Bryant Development and Review Committee Meeting

Date: December 29, 2022 - **Time:** 9:00 AM

6. Cornerstone Montessori Christian Academy - Springhill Road

Hope Consulting - Requesting Site Plan Approval

SITE PLAN
CORNERSTONE
CITY OF BRYANT, SALINE COUNTY, ARKANSAS

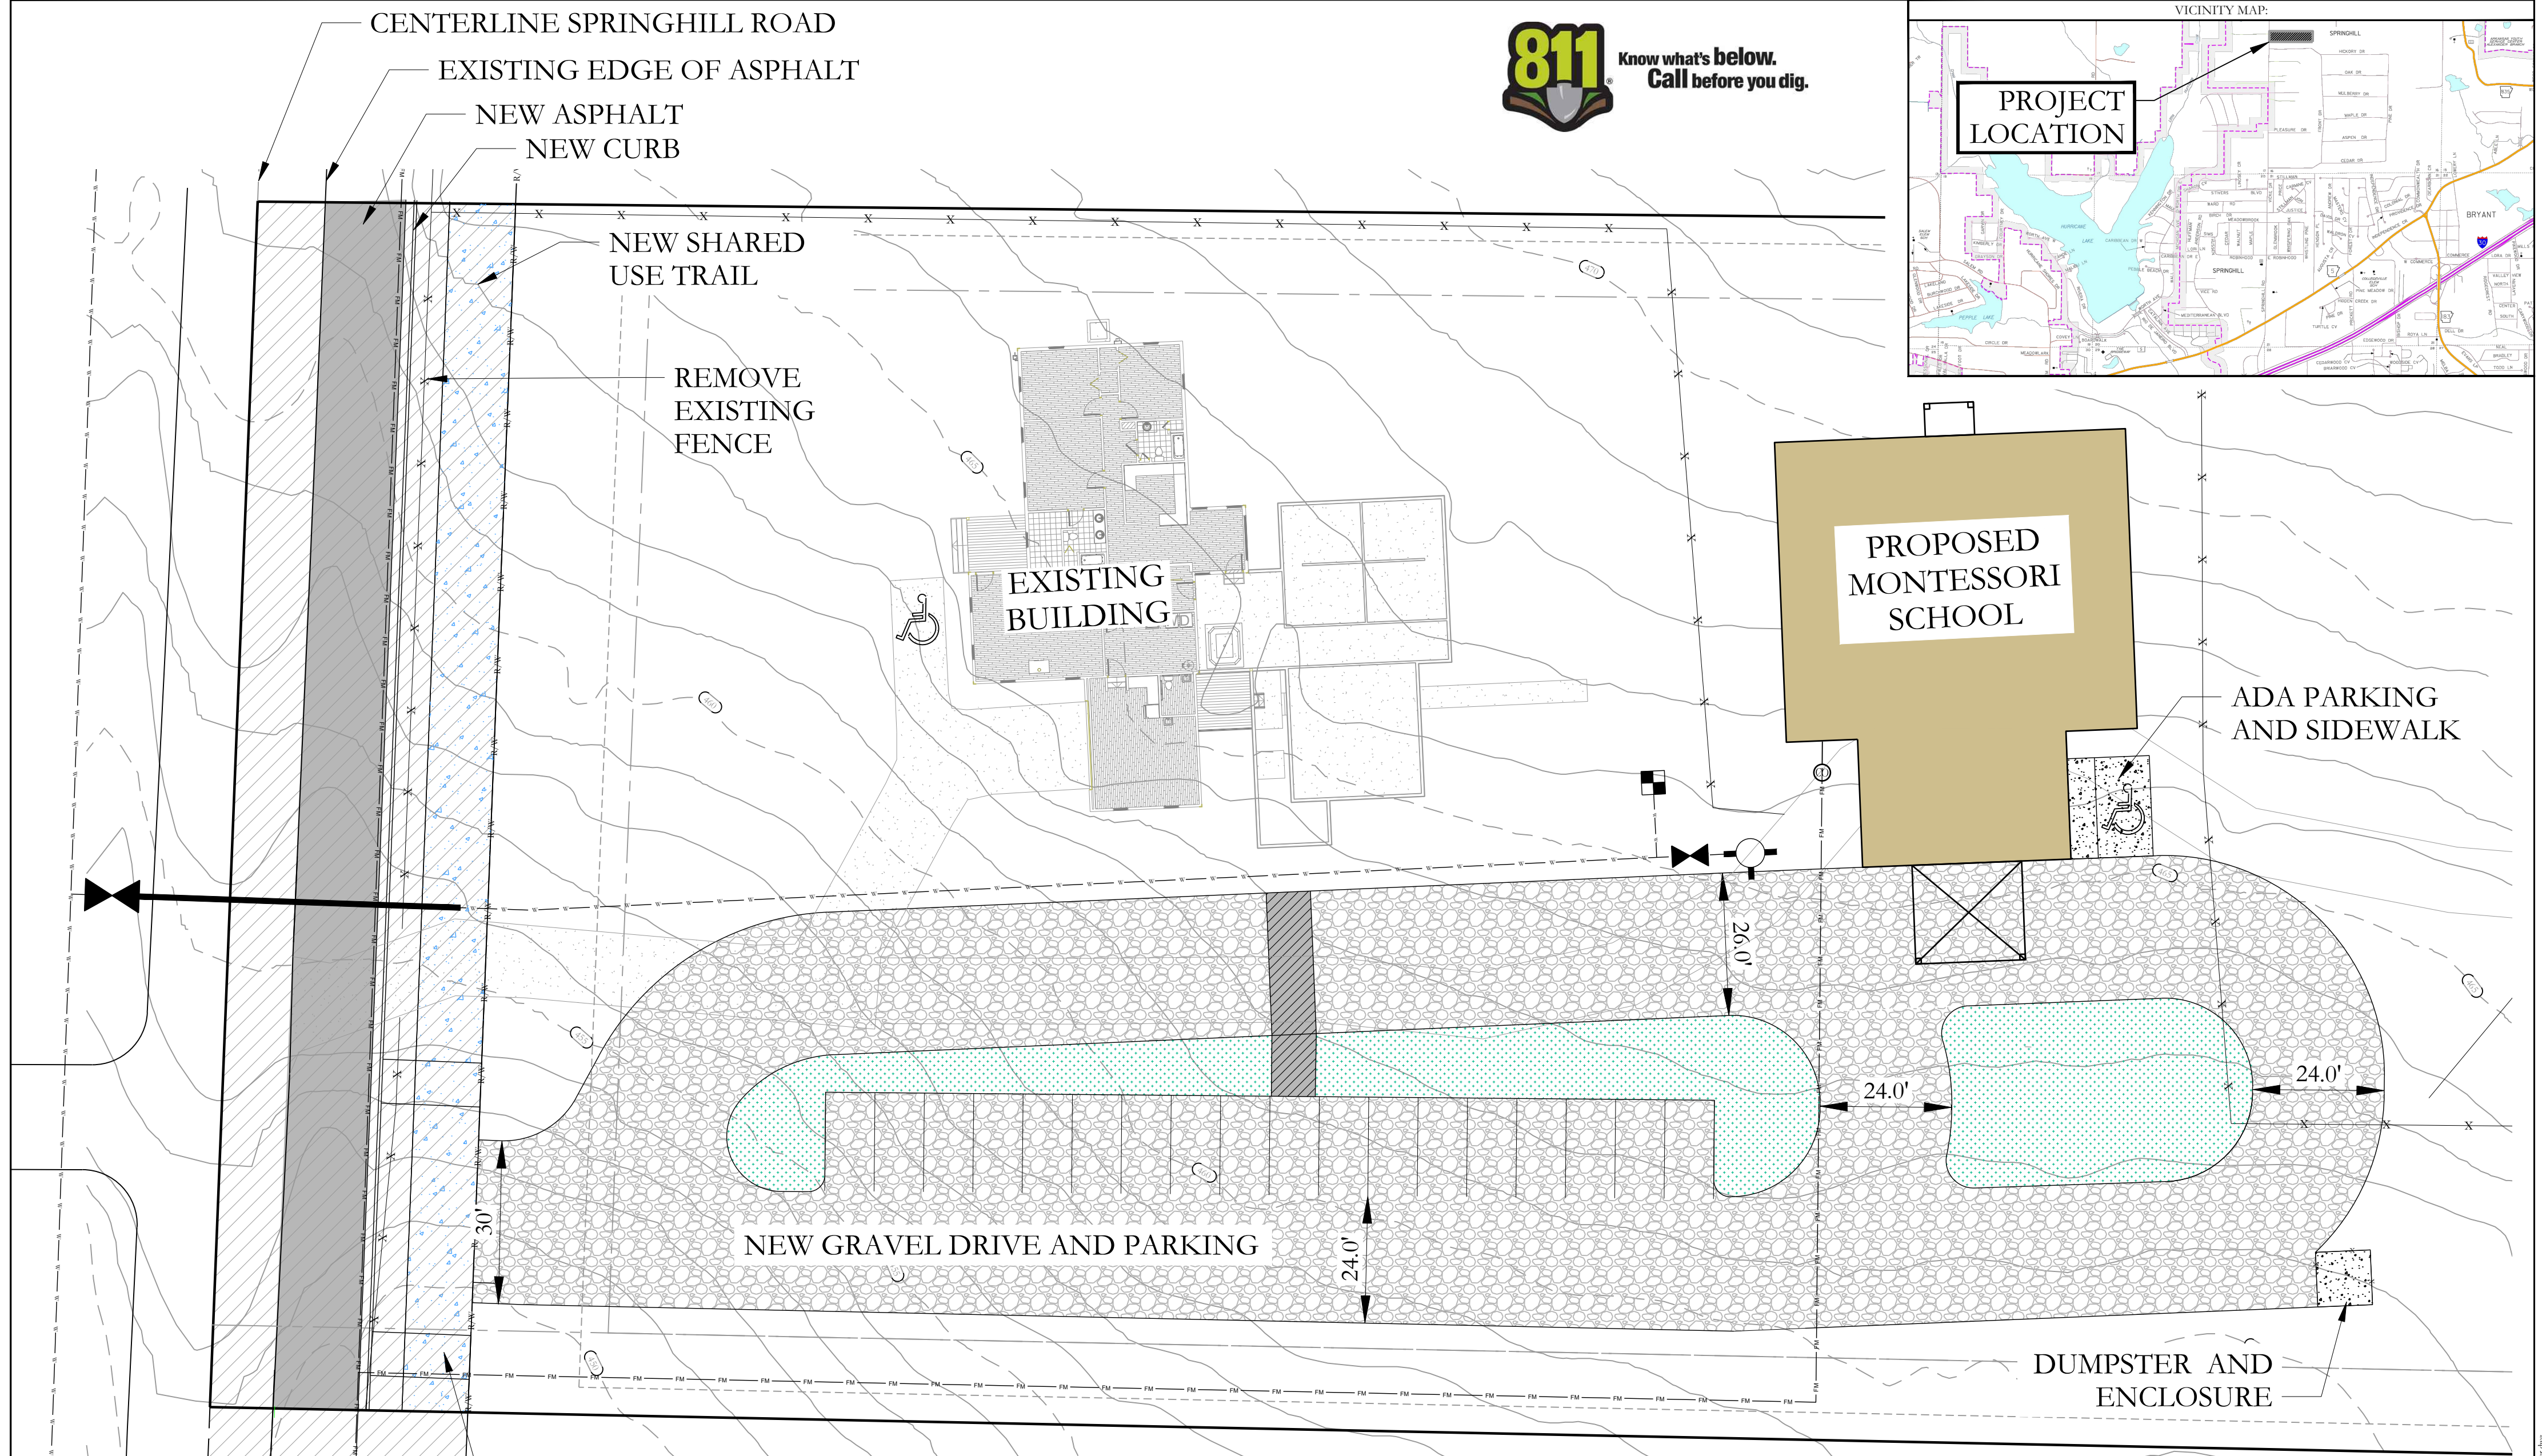
8. Provide elevations with façade materials shown for the new building. [Architect is providing.](#)
9. Landscape Plan. [Landscape Plan included.](#)
10. The Fire Department Access Road shall be 26' wide, 10' in either direction of the fire hydrant. See the diagram shown in the D103.1 of 2012 Arkansas Fire Prevention Code. [Drive is 26' feet wide in excess of 10 feet in either direction of the fire hydrant.](#)
